# **Bell Helicopter** **TEXTRON**

## **INFORMATION LETTER 206L-02-73**

**SUBJECT: MAIN ROTOR FLAP RESTRAINT KIT 206-706-013 CHANGE IN INSTALLATION PROCEDURE**

Figure 1 Support 206-010-191

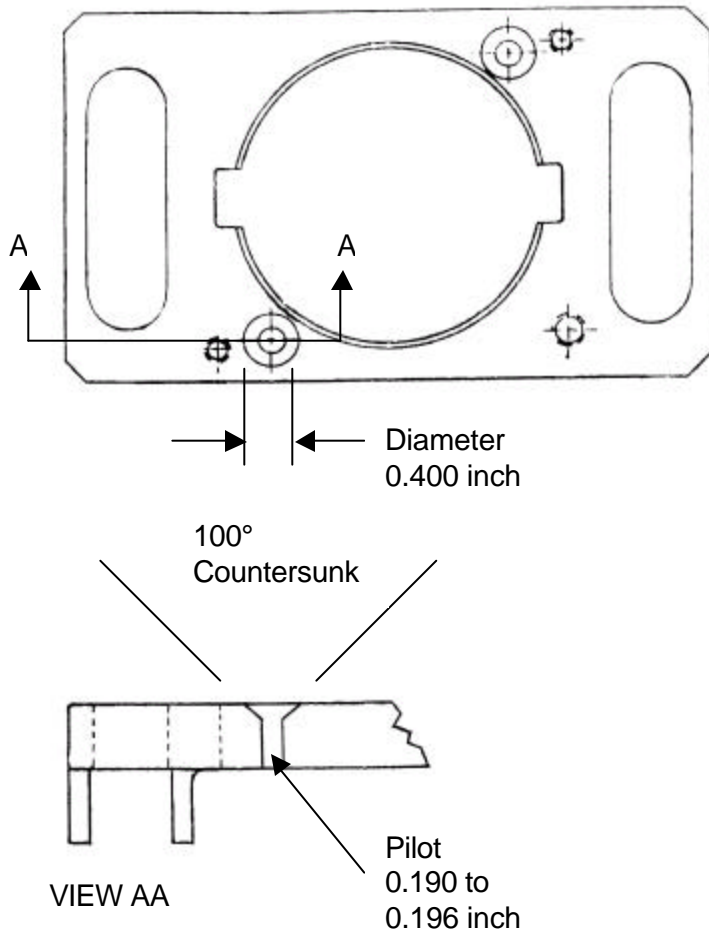
One of two conditions may contribute to this potential interference. Some 206-010-191 supports may have been manufactured with the countersinks for the attaching screws not deep enough. Primer or paint may have been applied to the plate, reducing the dimension of the attachment screws countersink.

Either of the above conditions may cause the screw head to protrude above the surface and foul the mast nut when the mast nut is tightened. This condition is not a safety issue but the protruding screws head may damage the mast nut and in extreme conditions affect the mast nut torque.

Use a straight edge placed on the screws head to ensure the screw heads do not protrude above the support. If the screws head protrude, check the support countersinks for presence of primer or paint. Remove any primer or paint from the countersinks, and repeat the straight edge check. If a screw head is found to protrude after the paint removal, rework the support as follows:

1. Using a press drill and a 100° countersink bit with a 0.190 to 0.196 inch diameter pilot, machine the countersink as shown in figure 1.
2. After rework brush cad plate the countersink. Do not apply primer or paint to the countersink surfaces.
